Brick v.6.5 modifications for version 6.5.1.

Summary: This document describes the component changes on LVPS brick (3.3V, 5V, or 15V versions) from produced version 6.5 into version 6.5.1. All mentioned component names and values are referring to the scheme components designed by Ivan Hruska of version 6.5 (or 6.4 as seen in this document on page 3).

REV: 6.4	DATE: 28.2004	ENG: WANHRUSKA
PROJECT: U/I ISOLATED BRICK FOR PILEAL		
COMPANY: GERIN		
ADDRESS: GENÈVE		
CITY: GENÈVE		
COUNTRY: SWITZERLAND		
INITIAL: _____	DATE: 27.2.2002	PAGE: 1 OF 1

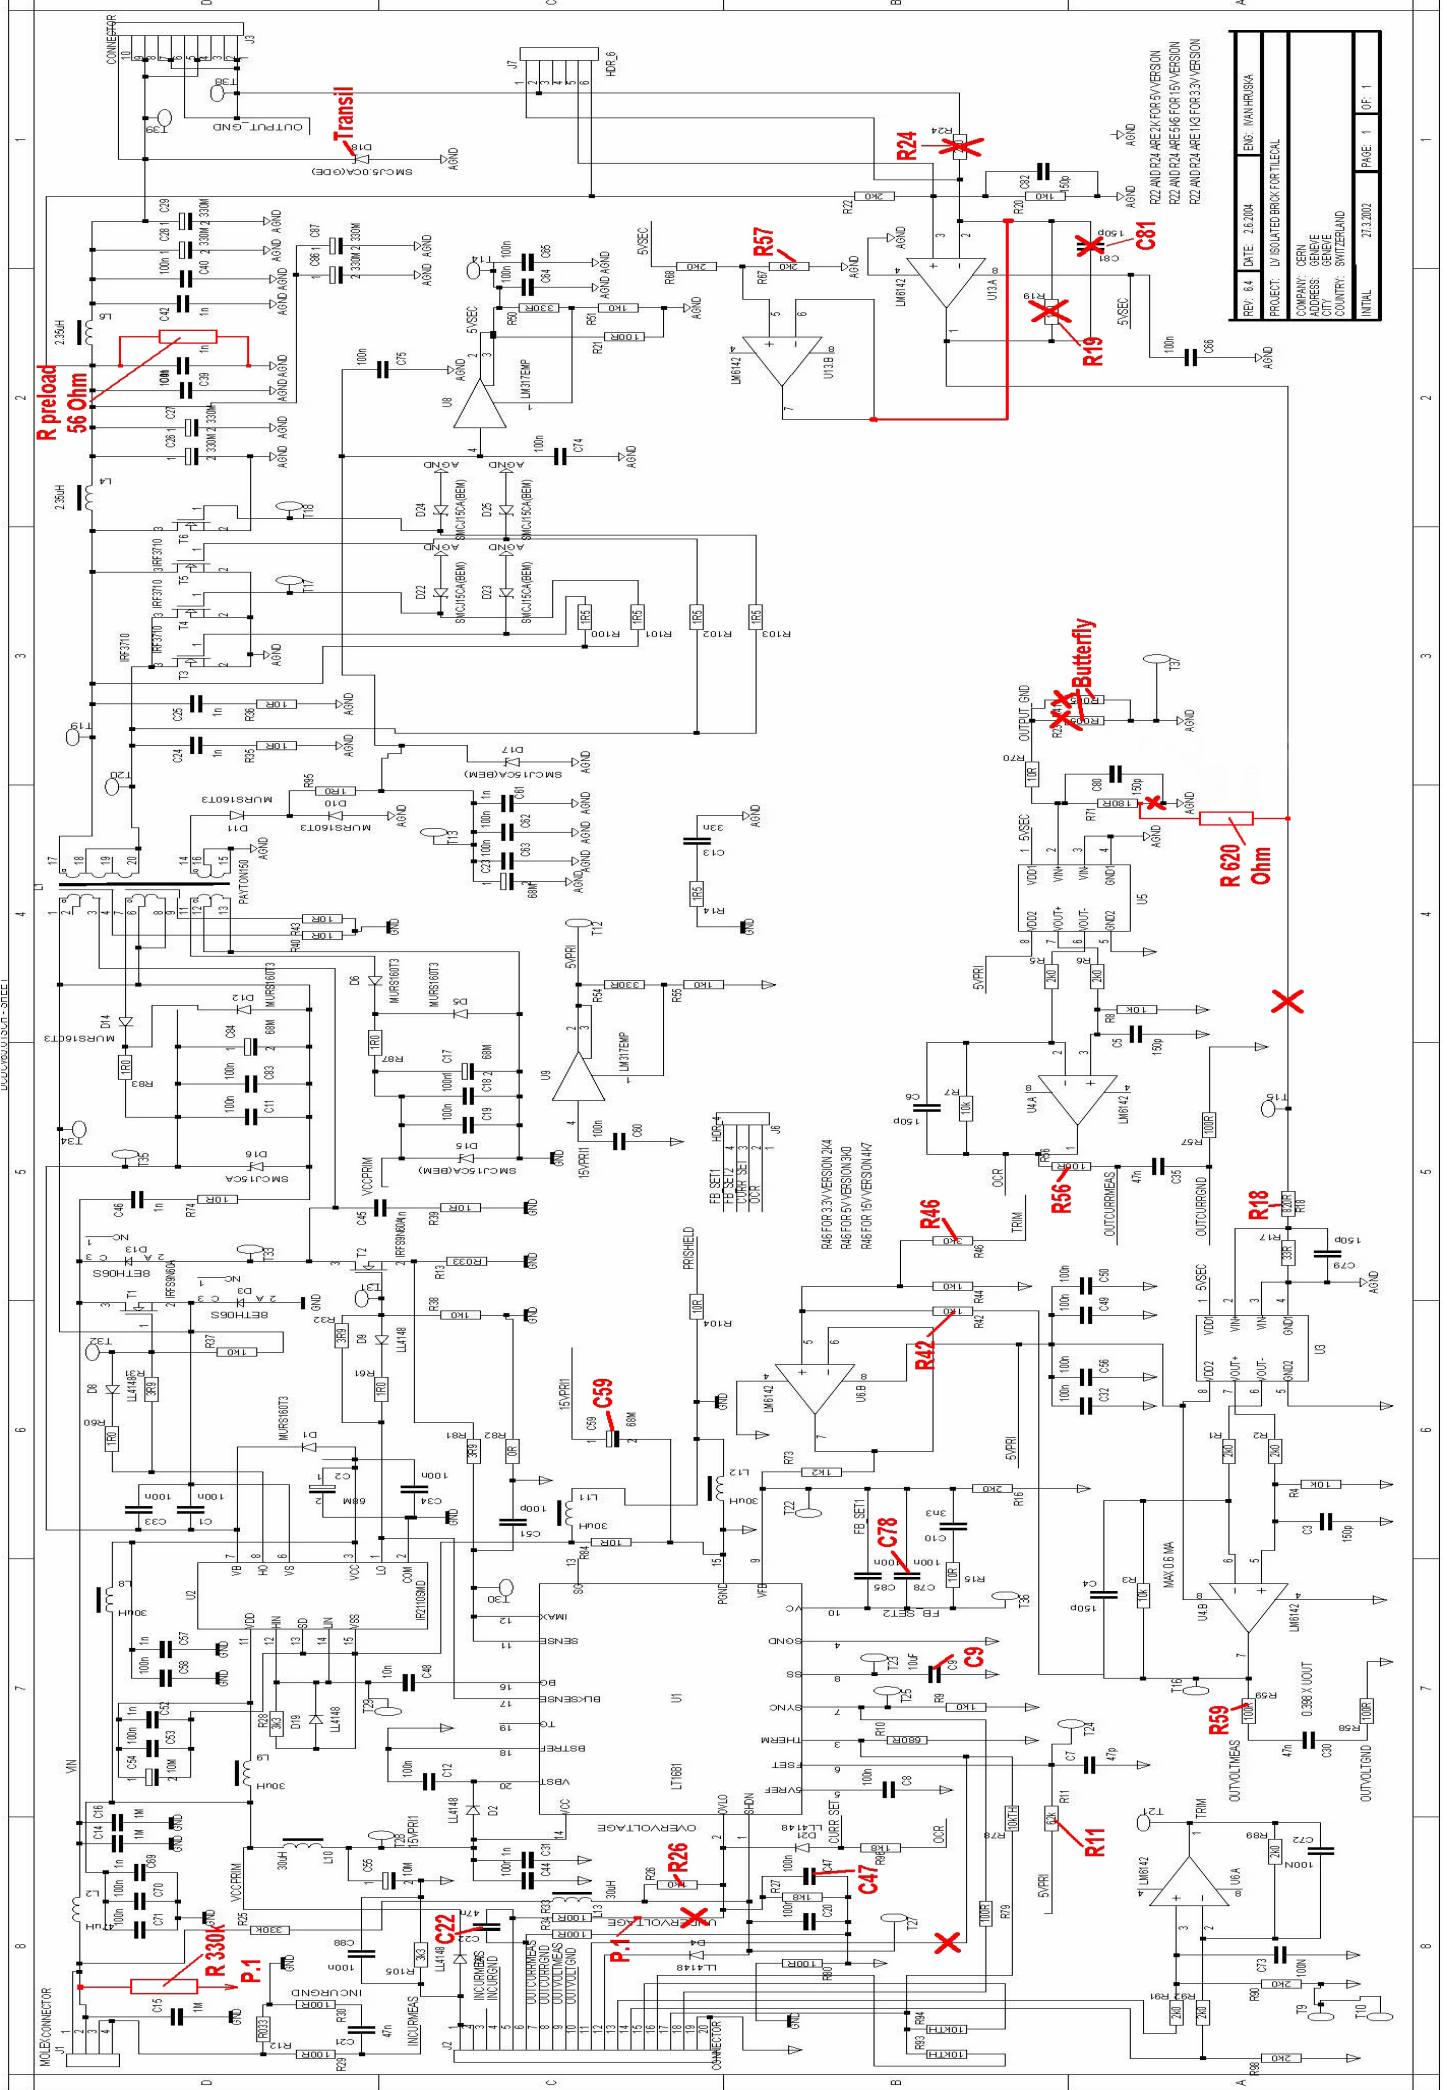
1. Cutting PCB wires:
 - between T15 and pin 1 of U13
 - between GND pins R71 and C80
 - “Butterfly” on top and bottom side.
2. Providing two wired short cuts:
 - connecting the Divider R17, R18 to the output filter.(30 mm piece of wire with isolation)
 - between pins 7,6 and 2 of the U13 to provide reference for the comparator.
3. Unsoldering R19, R24, C81 and C66
4. Changing the value of the resistor R18 by table 1:

6. Soldering one 620 ohm resistor between U13 (pin 1) and R71. (to provide comparator function through the current feedback.)
7. Unsoldering C47 (to speedup the OVP reaction.)

8. Remove TRANSIL from output of the Brick.
9. Unsoldering and removing C59.
10. Changing the value of the resistor R11 = 62kOhm (switching frequency 300 kHz) to 100kOhm (switching frequency = 215 kHz).
11. Changing the value of the resistors R56, R59 = 100Ohm to 10kOhm. (Protects feedback gain from influence of ELMB power cycles.)
12. Unsoldering R26 = 1kOhm (undervoltage = 190V). Soldering R26 = 1.5kOhm (undervoltage = 135V).
13. Cut trace from pin 11 of J2 connector. (Disconnect ELMB from LT 1681's Thermal Shutdown pin 3, by removing one Temperature measurement. Thermal shutdown will still function)
14. Cut line between R33 and OVLO pin 2 (LT 1681), then this point through 330k resistor connects to +200VDC. And change C22 to R = 1.8k (Additional 200V divider for V input measurement.)
15. Unsoldering C78 = 100nF. Soldering C78 = 10nF. (Speedup of feedback.)

16. To start Bricks in sequence it is necessary to change C9 by table 3:

17. Soldering sense-resistors (instead of “Butterfly”) by table 4:

18. Adjust feedback gain:

- Brick starts at minimum trimming: measure V_{out}
- By formulas in Excel calculate additive (parallel) resistor for R42:
- $R_n = 2 * (V_{theor} / V_{out}) - 1$;
- $R_{add} = R_n / (1 - R_n)$;
- Take nearest nominal in row E24(1%)

19. Additional modifications for 15V bricks:

- Replace R45: from 4.7k to 7.5k (to reduce trimming range)
- Put preload resistor: 56 ohm

Brick type	R18(new value)
3.3V	1.1k
5.0V	1.8k
15.0V	5.1k

Brick type	R57(new value)
3.3V	1.0k
5.0V	1.3k
15.0V	1.8k

Brick type	Value of C9*	Starts in group
-5V MB	1.2uF	1
+5V MB	10uF (not changed)	2
+15V MB	25uF	3
+3.3V DIG	1.2uF	2
+5V DIG	10uF (not changed)	3
-15V HV	1.2uF	1
+15V HV	10uF (not changed)	2
+5V HV	25uF	3

Brick type	Value of sense-resistor	OCP
-5V MB	2x5mOhm	16A
+15V MB	5mOhm	8A
+5V MB	1.5mOhm (1mOhm)	20A
+3.3V DIG	2x5mOhm	16A
+5V DIG	2x5mOhm	16A
-15V HV	5mOhm	8A
+15V HV	5mOhm	8A
+5V HV	5mOhm	8A
